REMARKS

AMENDMENTS TO THE DRAWINGS

FIG.13
CONVENTIONAL ART

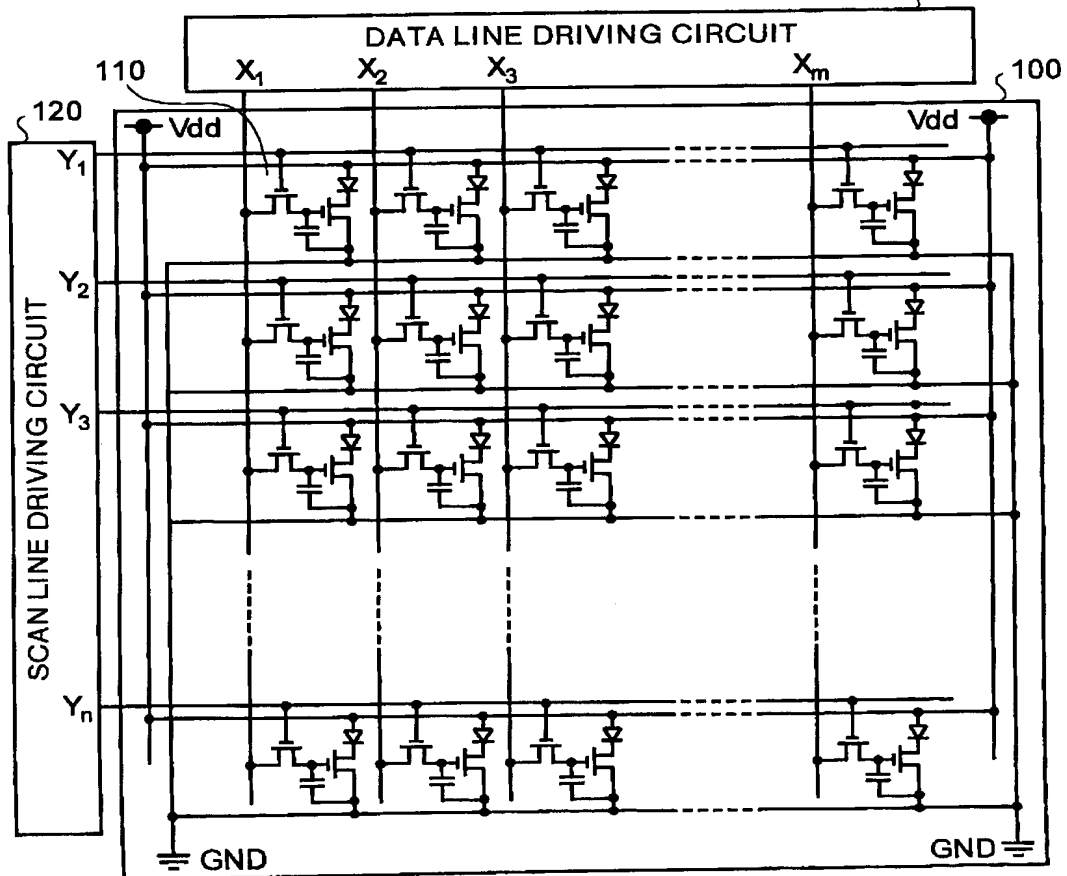
The drawings are objected to because it is alleged that Figures 13 and 14(a)-14(b) are not labeled correctly. *See Office Action, page 3, items 4 and 5.* The drawings have been amended to address this objection. Applicants request that the objection to the drawings be withdrawn.

- Figures 13 and 14(a)-14(b) are designated with the legend "Conventional Art" as required in the Office Action.
